BID NO. LCF 25/26-03
SITEWORK/SITE UTILITIES FOR MODULAR BUILDINGS INSTALLATION PHASE 2
AT PARADISE CANYON ELEMENTARY SCHOOL

ADDENDUM NO. 3

PROJECT NUMBER: 95150

LA CAÑADA UNIFIED SCHOOL DISTRICT

5C1.52

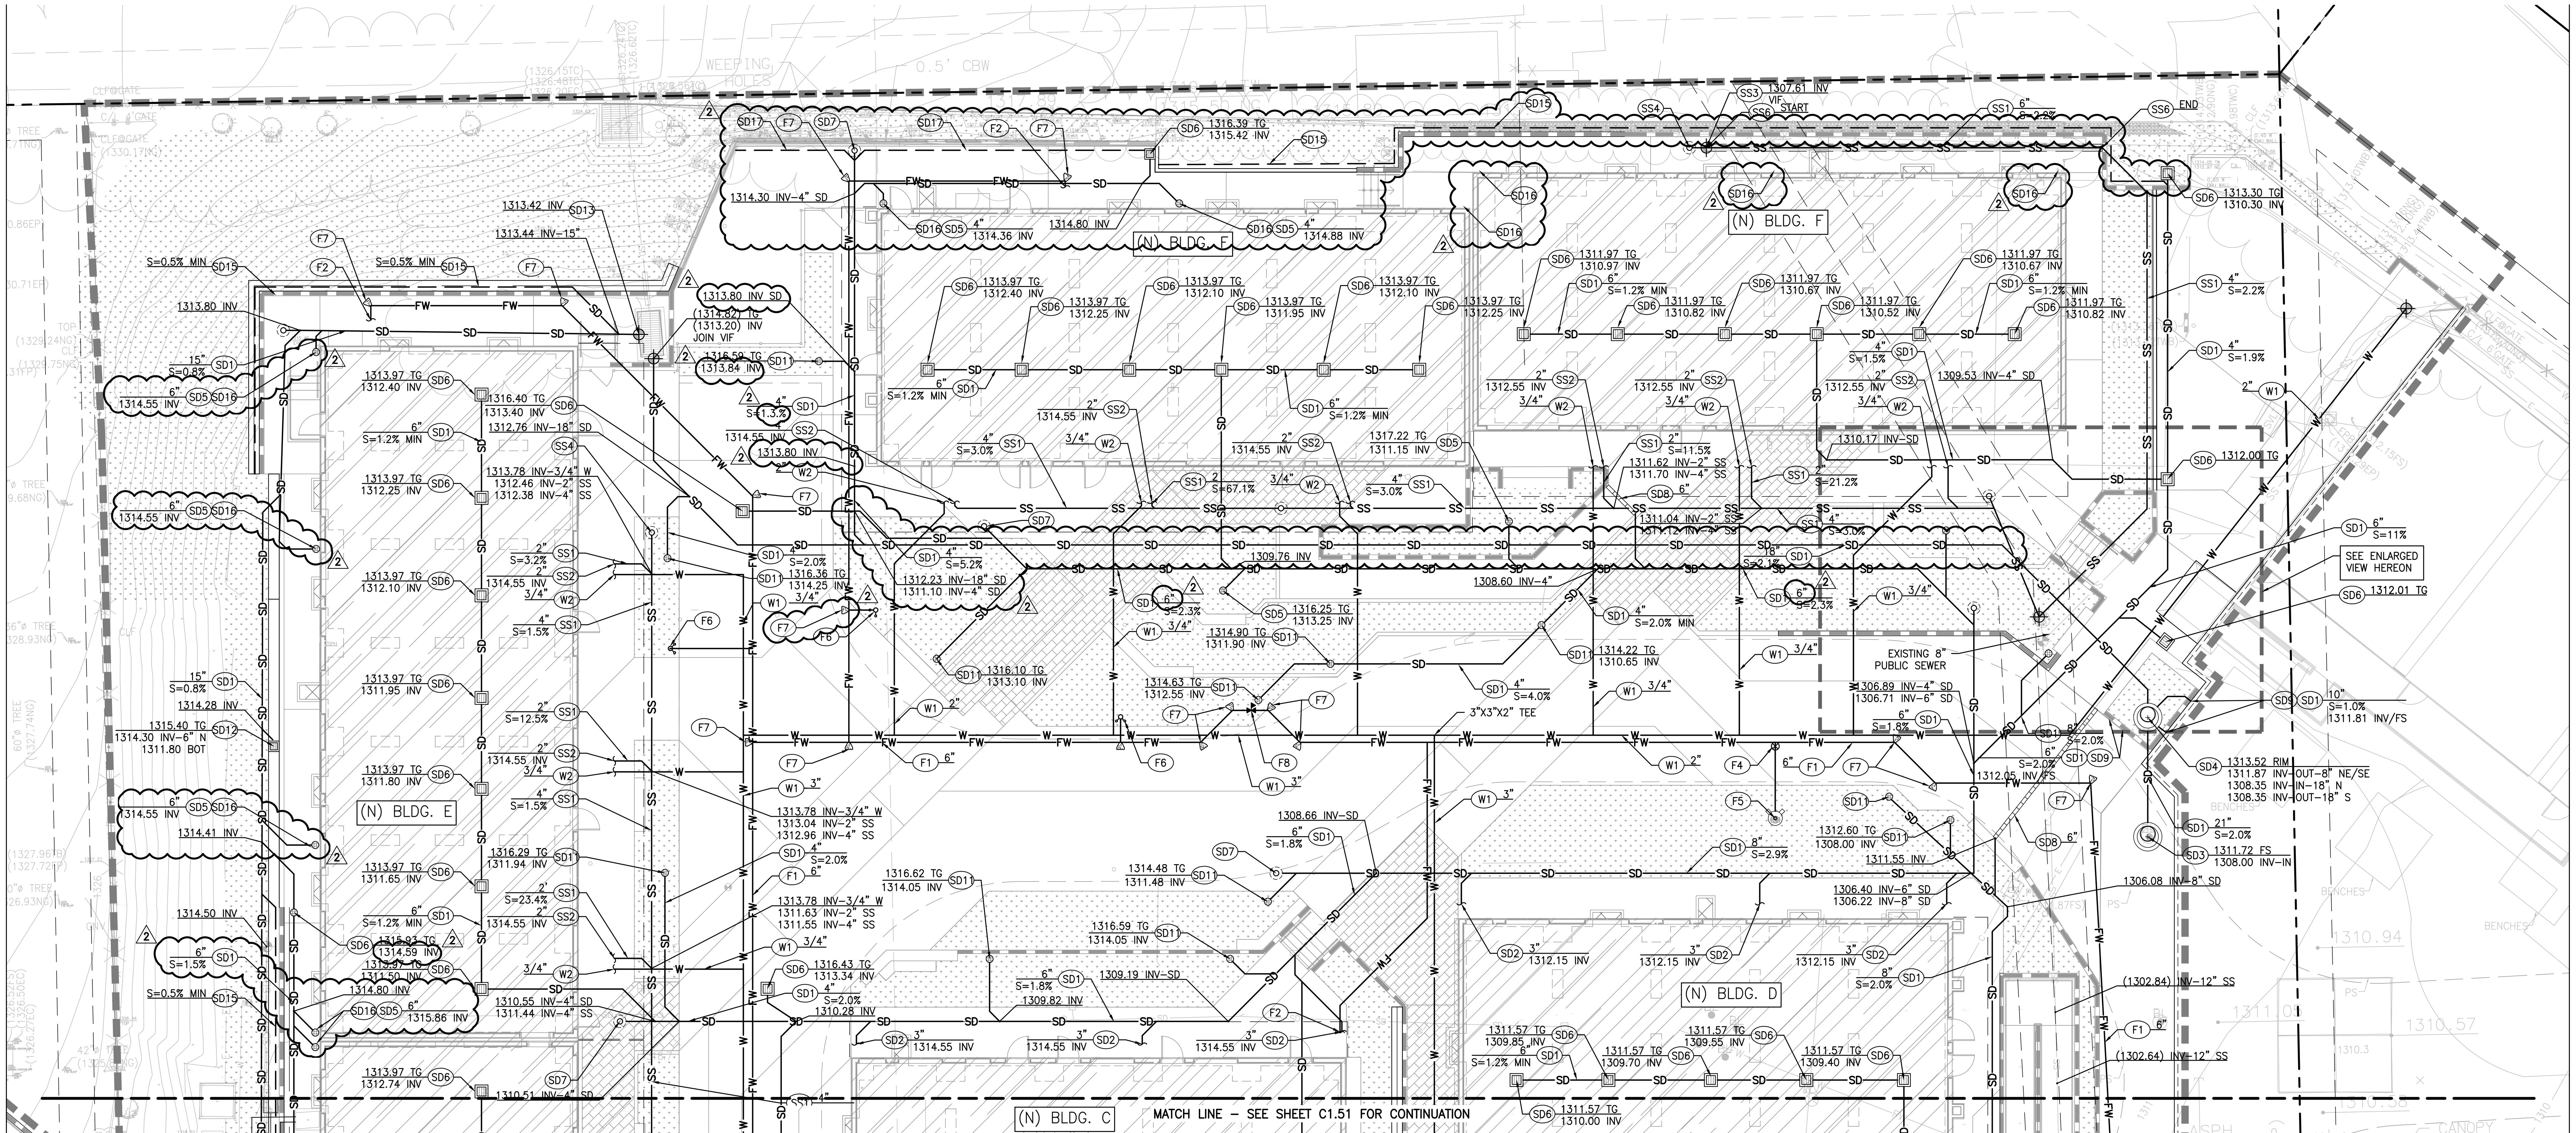
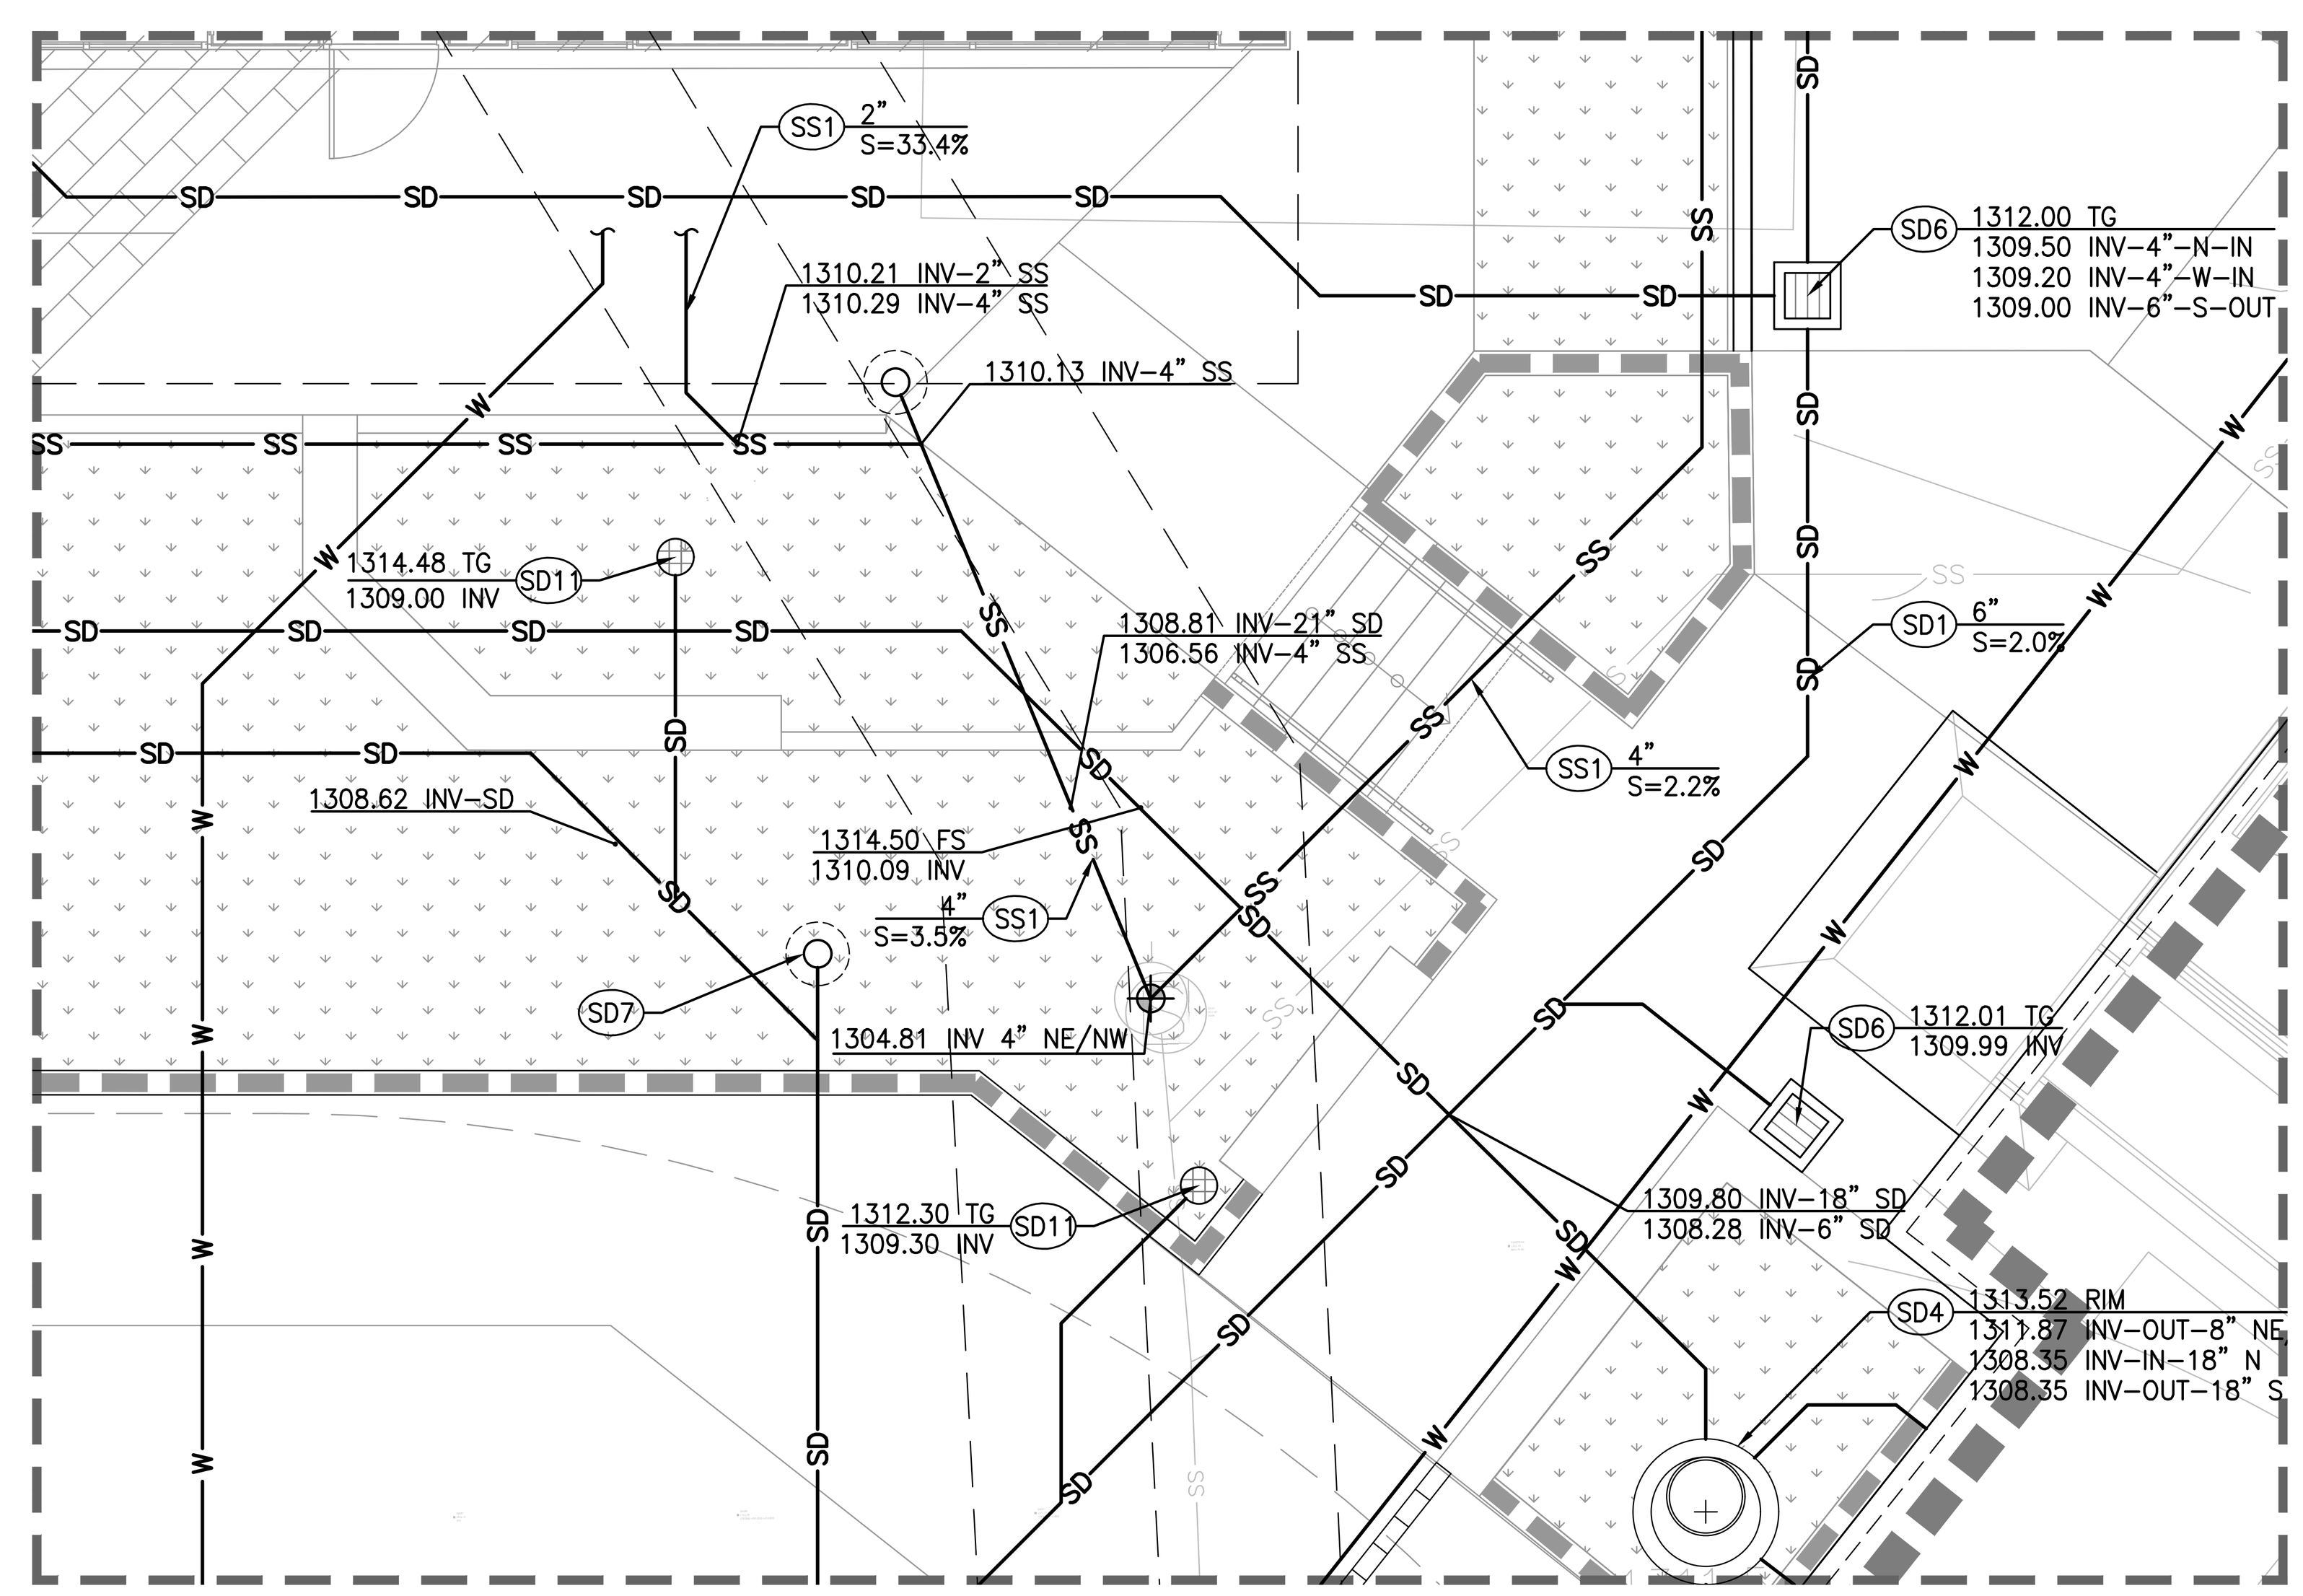
Item No. AD-3-16:
Drawing: 5C1.52 – UTILITY PLAN
Revisions: Roof drain revised to match plumbing. Area drains and piping added to plan where required. SD9 Storm Drain Daylight construction note reference added. SD17 Perforated Pipe construction note added.

9 EXISTING WALL PERFORATED DRAIN N.T.S.

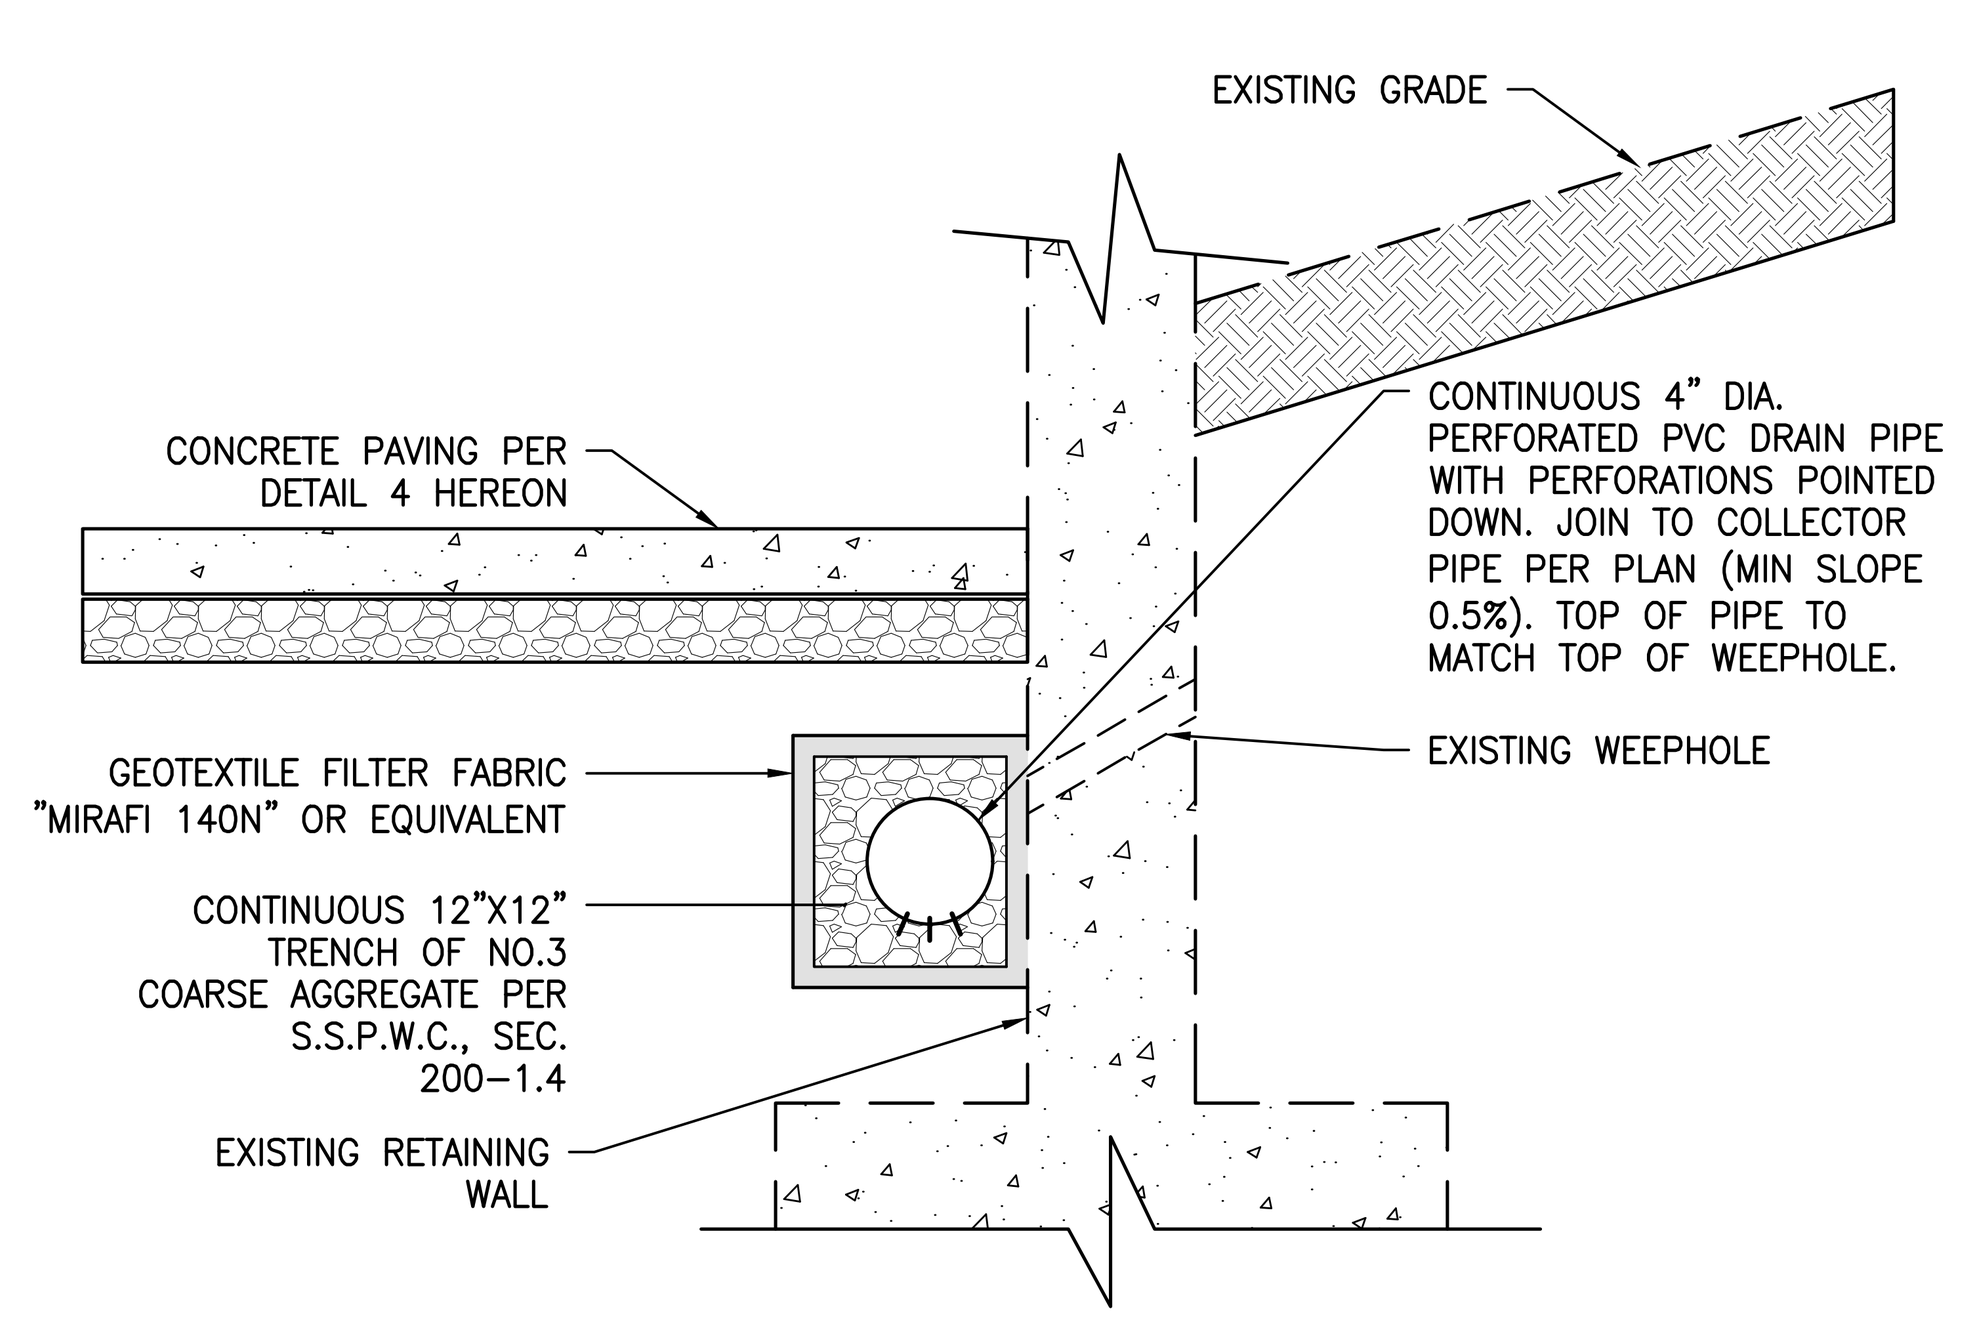
Item No. AD-3-17:
Drawing: 5C5.00 – DETAILS
Revisions: Existing Wall Perforated Drain detail added (9/5C5.00).

2 WEEPHOLE N.T.S.

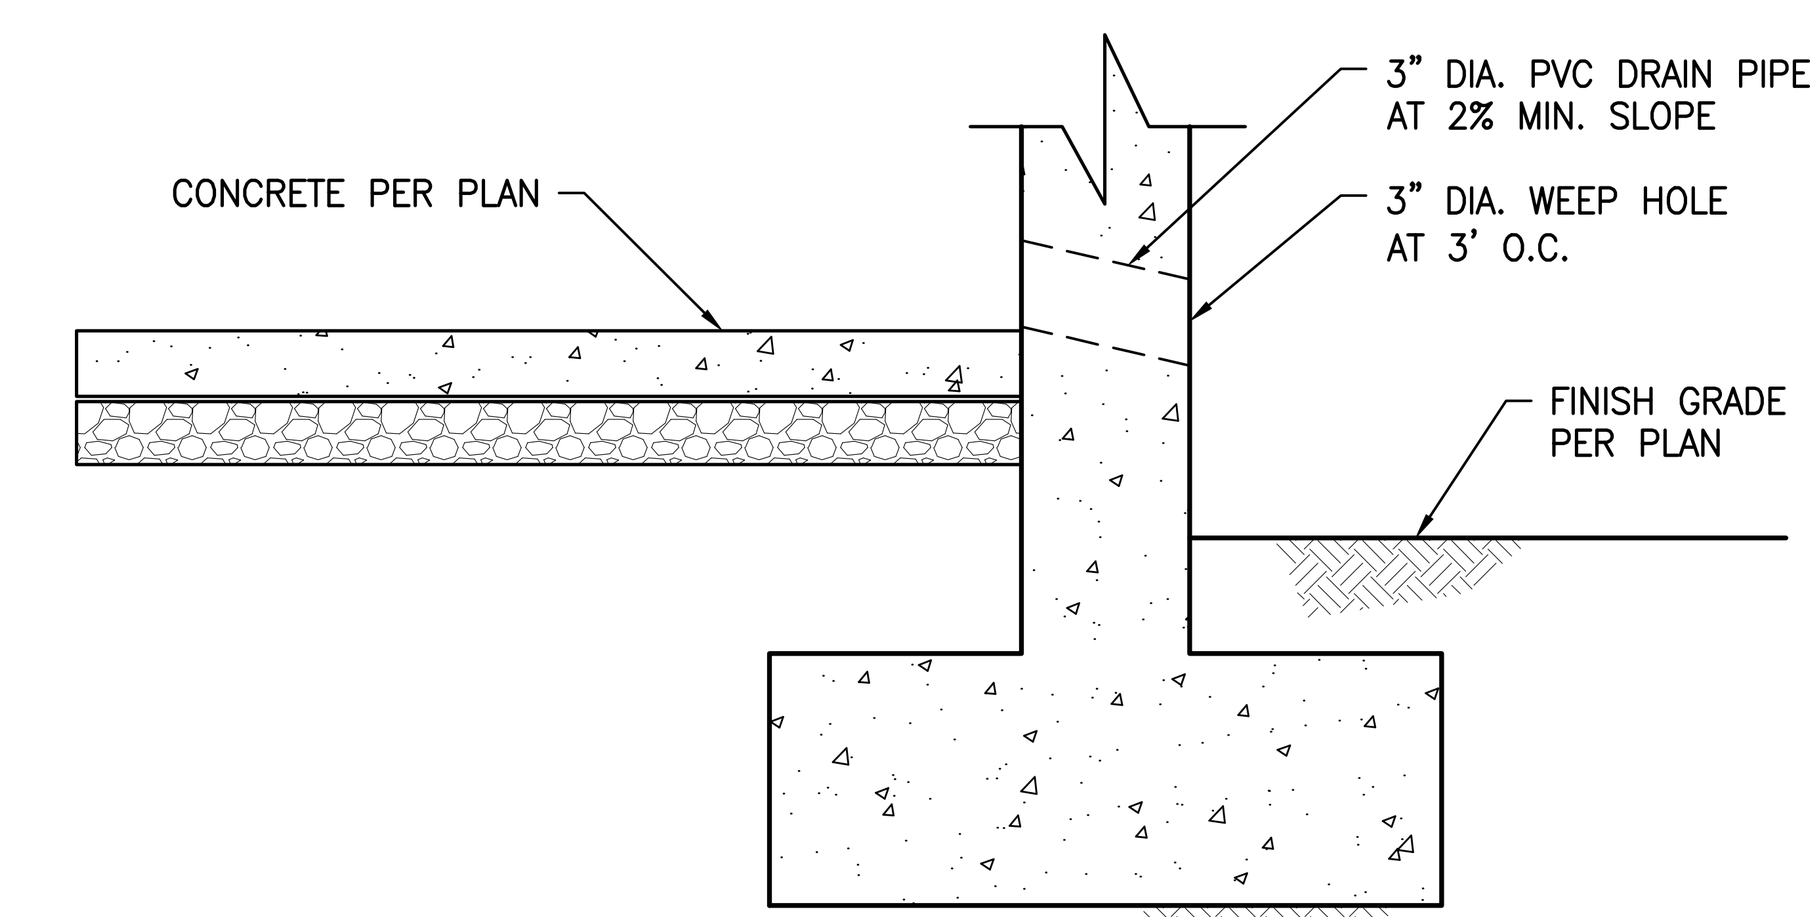
Item No. AD-3-19:
Drawing: 5C5.02 – DETAILS
Revisions: Asphalt Pavement detail revised (1/5C5.02). Weephole detail added (2/5C5.02). Storm Drain Daylight detail added (4/5C5.02). Wall Drainage detail revised (7/5C5.02).
